COMMUNITY DEVELOPMENT DEPARTMENT REPORT

HEARING DATE: 5/28/2026
TO: Planning & Zoning Commission
FROM: Sonya Allen, Associate Planner
208-884-5533
sallen@meridianscity.org
APPLICANT: Benjamin Semple
SUBJECT: Starling Ridge Subdivision
H-2026-0009

LOCATION: Generally located 1/2 mile south of E. Lake Hazel Rd., on the east side of S. Eagle Rd. in the SW 1/4 of Section 4, T.2N, R.1E.

Annexation of 61.34 acres of land with R-4 (25.62 acres) and R-8 (35.72 acres) zoning districts; and preliminary plat consisting of 211 building lots and 26 common lots on 60.43 acres of land in the proposed R-4 and R-8 zoning districts.

D. Phasing Plan (date: 5/12/2026)

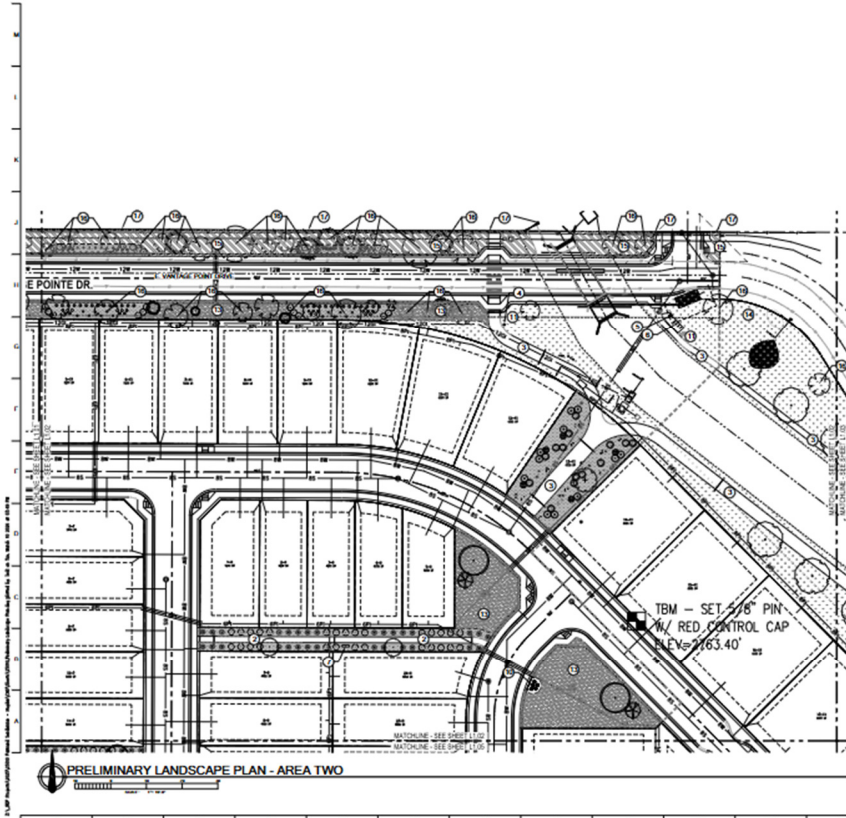
The applicant has indicated they plan to phase the development into six (6) different phases. However, the phasing plan shall be revised to incorporate the main open space (Lot 7, Block 1) with Phase one (1) of the development. Based on these factors and with the recommended changes presented above, staff finds that the proposed preliminary plat and R-2, R-4, and R-8 zoning districts are generally consistent with the Future Land Use Map designation of Low Density Residential.

- a. Add a plat note stating “direct lot access to S. Eagle Road is prohibited.”
 - b. Revise the phasing plan to incorporate Lot 7, Block 1 with Phase One (1) of the development.

PRELIMINARY LANDSCAPE PLAN
AREA TWO

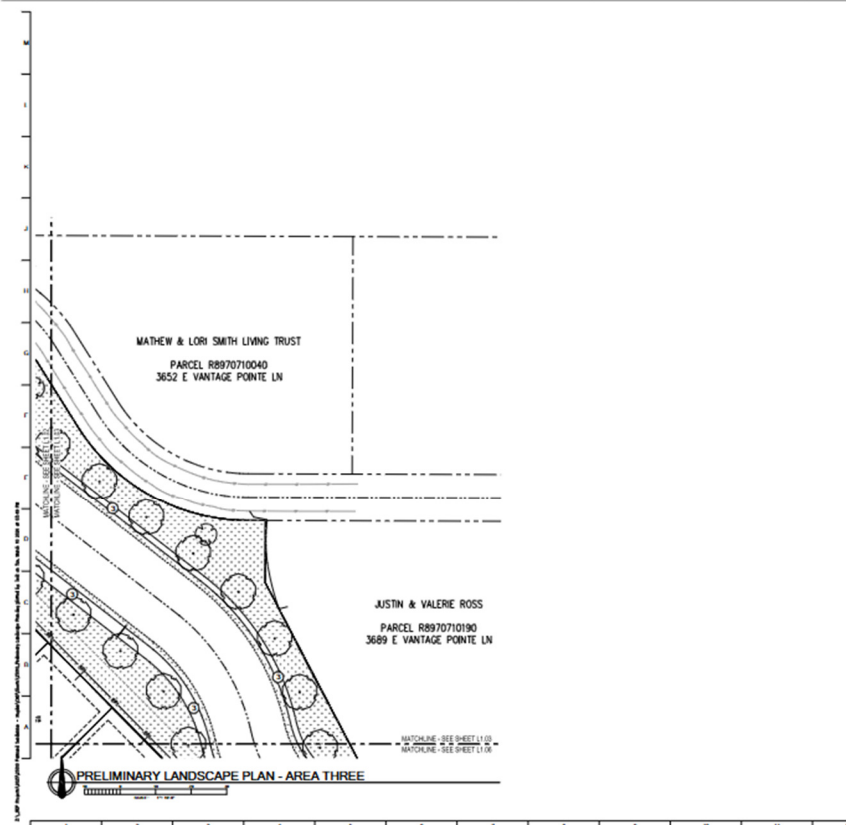
UDC Requirement	Proposed/Analysis
Arterial Road: 25 Feet	The applicant did not specify the width of the landscape buffer. However, it appears to be 25 feet in width. In addition, the landscaping does not appear to meet the 70% vegetation coverage requirement. These shall be revised with the final plat.
Local Road: 10 Feet	The applicant did not specify the width of the landscape buffer. However, it appears to exceed the 10 feet required along the local road on the north portion of the site.

- iv. Pathway landscaping
 - Landscaping is required to be provided along all pathways per the standards listed in UDC 11-3B-12C.
 - A minimum of ten (10) feet of landscaping is required along pathways with no less than two (2) feet on any one side. In addition, a mix of trees, shrubs, lawn, and other vegetative ground cover shall be provided with a tree every 100 linear feet of pathway. The applicant does not meet the pathway landscaping requirements and shall revise their site and landscape plan to reflect compliance with these standards.*

- d. Provide vegetation coverage calculations for landscape buffers along streets to meet the required 70%. Sod and other grasses cannot comprise of more than 65% of the vegetation coverage.
